Subject: **PALEN SOLAR I, LLC'S INITIAL COMMENTS ON THE STAFF
ASSESSMENT/DRAFT ENVIRONMENTAL IMPACT STATEMENT
DOCKET NO. (09-AFC-7)**

Application for Certification for the
PALEN SOLAR POWER PROJECT

DOCKET NO. 09-AFC-7

**PALEN SOLAR I, LLC'S INITIAL
COMMENTS ON THE STAFF
ASSESSMENT/DRAFT
ENVIRONMENTAL IMPACT
STATEMENT**

Palen Solar Power Project
Figure Soil and Water-2
Project Only
Revised Construction
Water Supply

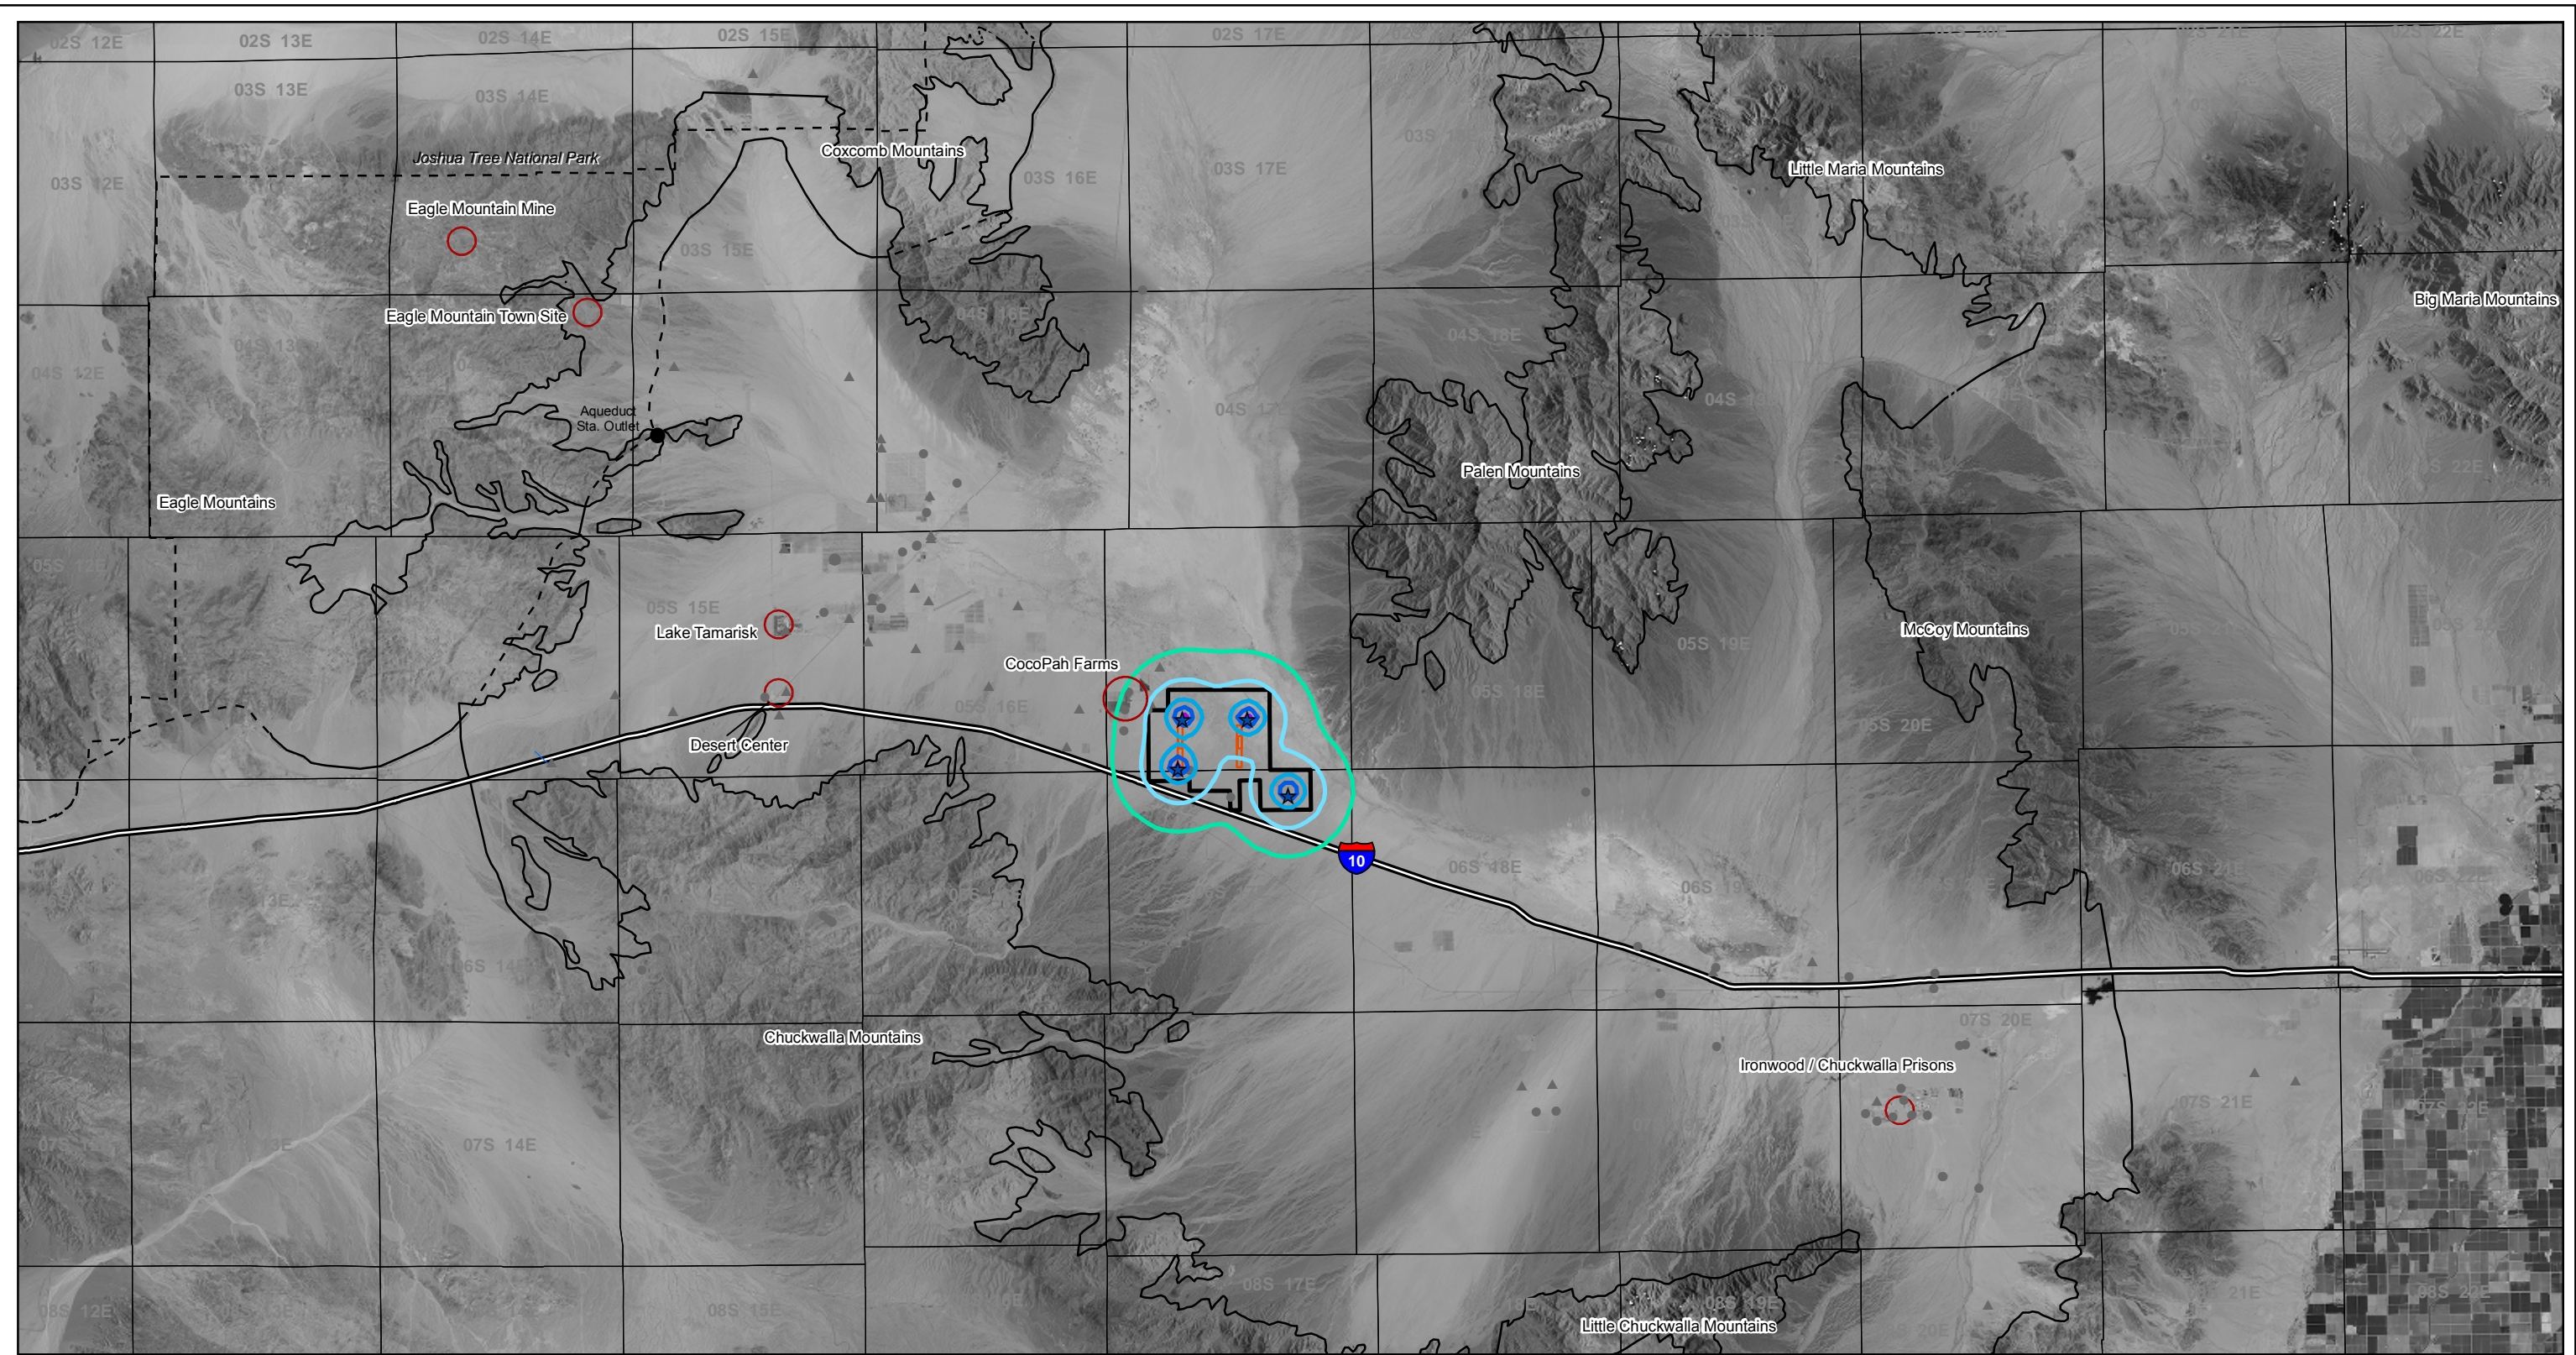
To supply the needed quantity of water and inconsideration of the proposed change in the construction water volume (see Condition-SOIL&WATER- 4 below) and based on the uncertainty in well yield due to the limited number of well tests performed to date, PSI proposes to install and operate up to 10 wells on site. The wells will be located within the power blocks and elsewhere within the solar fields to provide primary and secondary water supply to the Project. This is an increase in the number of on-site wells compared to the number proposed in the AFC. The implications for the Project impact analysis of the change in the number of proposed wells, along with the change in the proposed construction water volume is addressed in Attachment 2.

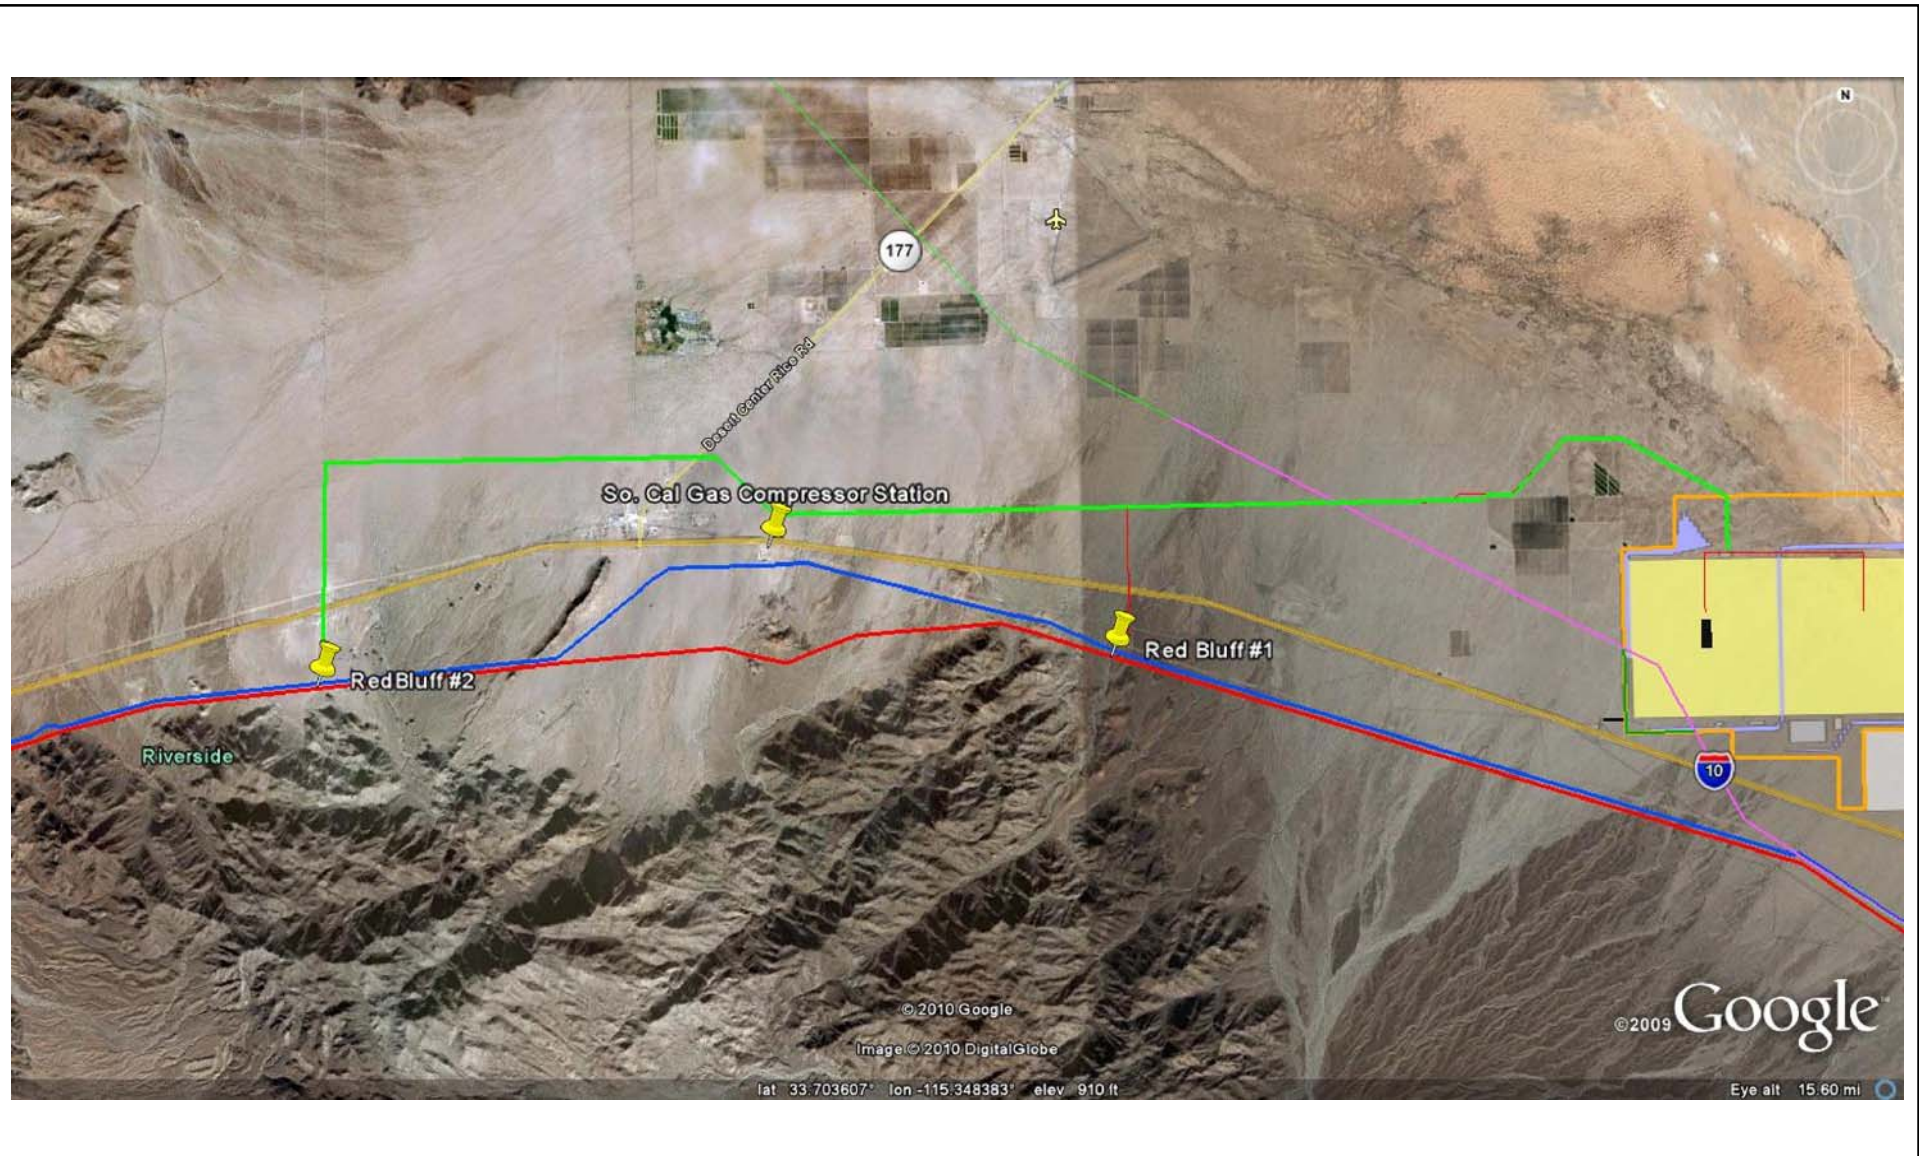
These changes are reflected in attached drawing 2008-045E-PP-001-ALT, Plot Plan Air Cooled Condenser Option (Power Block Layout_ RevE.pdf) for a revised plot plan and power block layout.

Figure 2-1 Area Sources Used in Short Term Construction Modeling Analysis

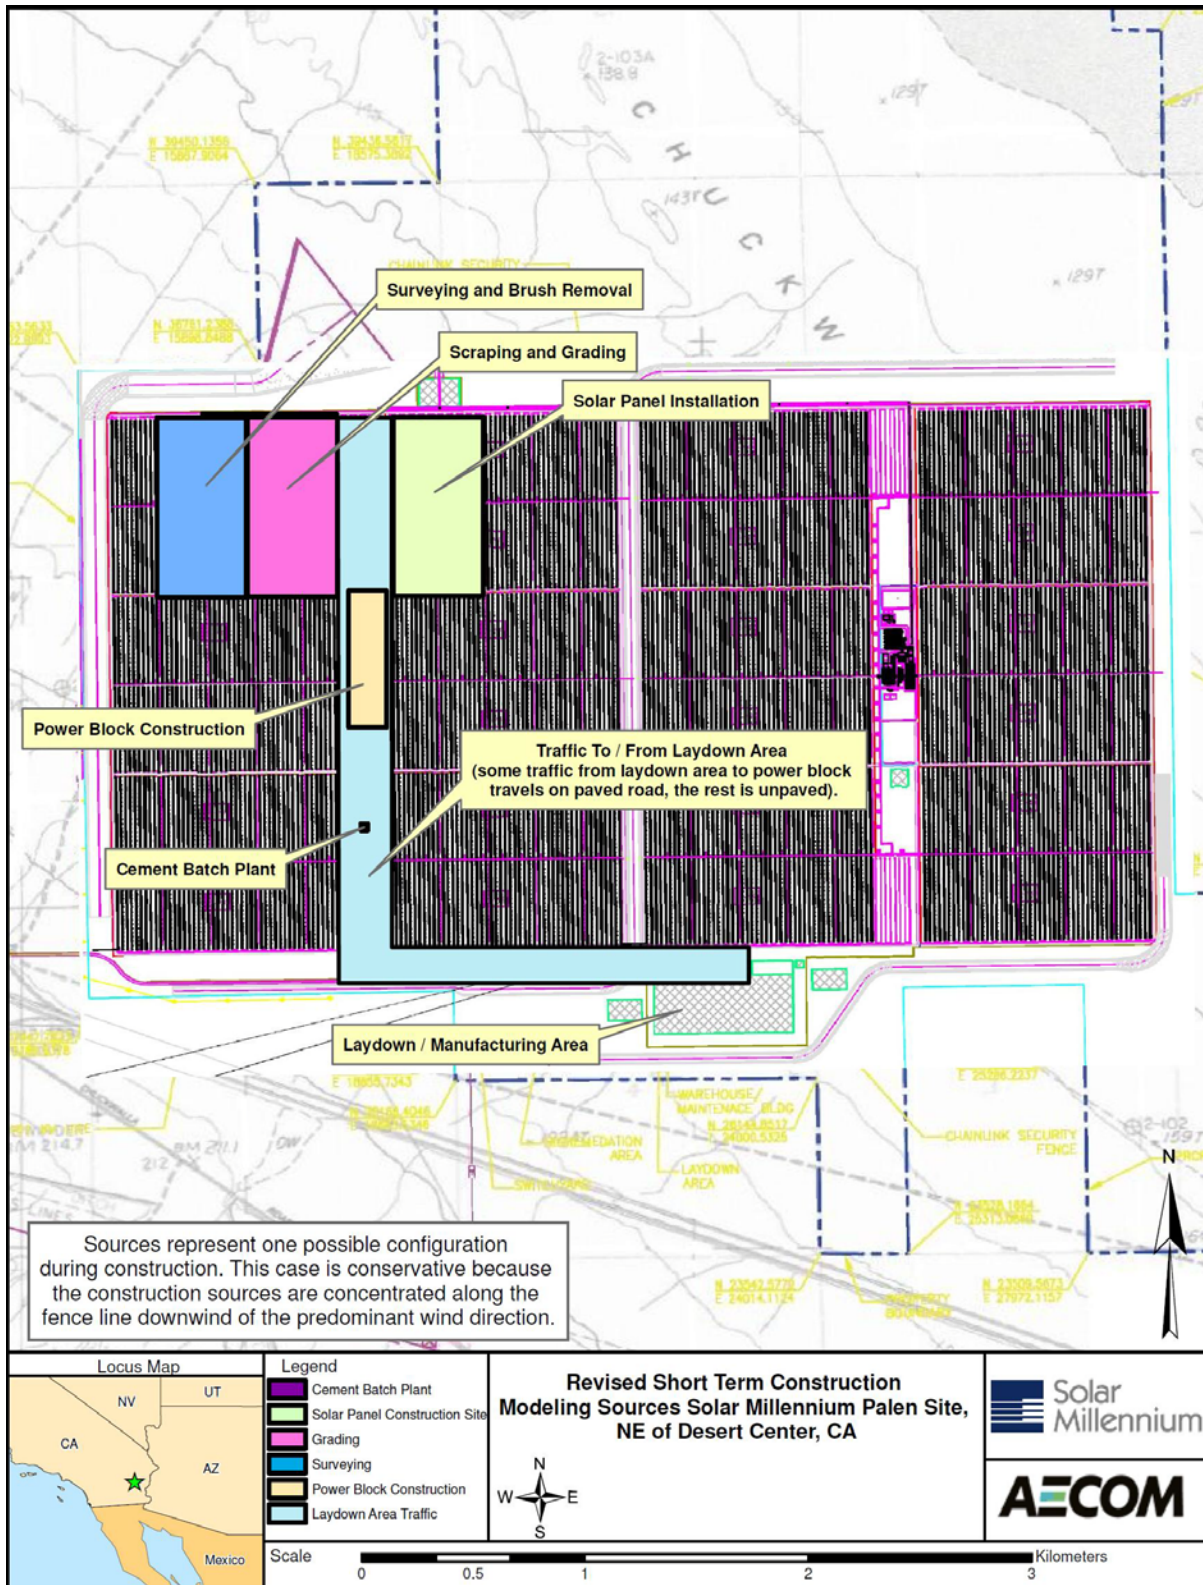
⁴ Results reflect 10-hour work days during construction from March through September and 8-hour days from October through February for all sources, with some sources remaining active during nighttime hours as described in Section 2.3.

Figure 3-1: Typical Power Block Layout for PSPP Used in GEP Analysis

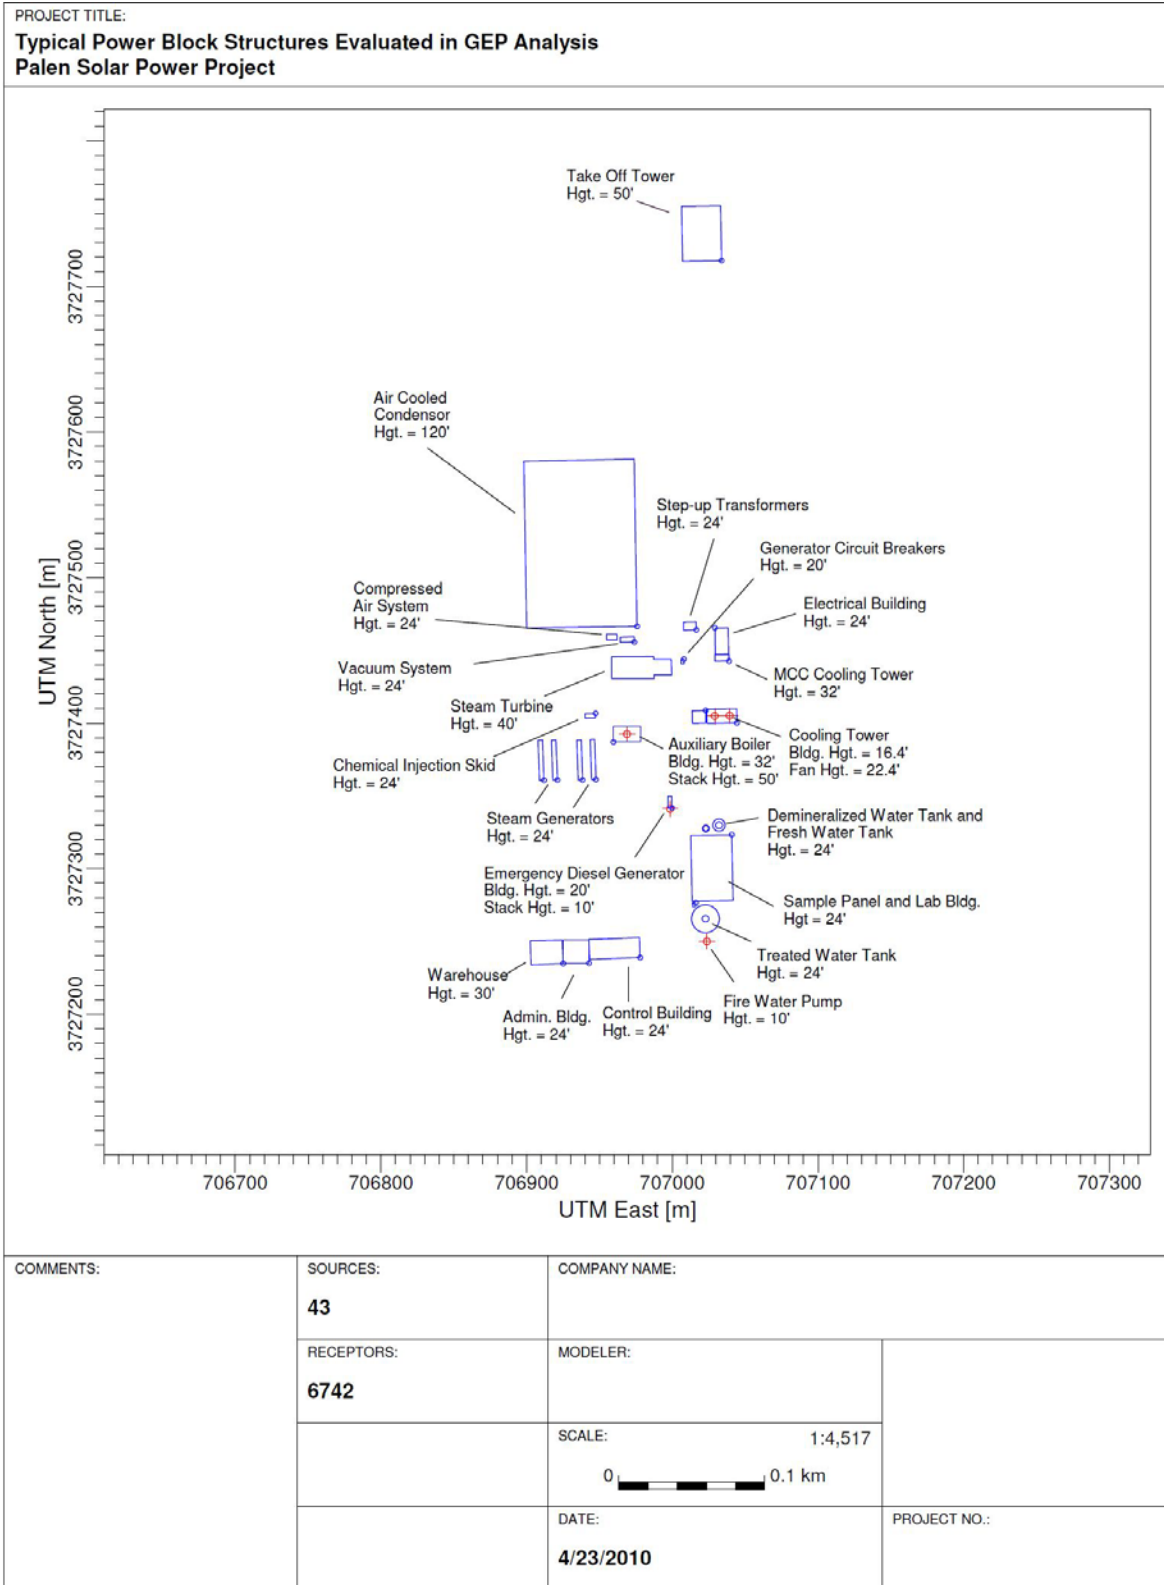
As discussed in Section 3.1, the equipment to be located at the two PSPP power blocks, including the emission sources, have been rearranged. As a result, the source locations were updated in the modeling and a new GEP analysis was performed to determine the effects of downwash due to nearby structures for each emission source. The results of the GEP analysis are shown in Table 3-1. The reconfigured power block is shown in Figure 3-1.
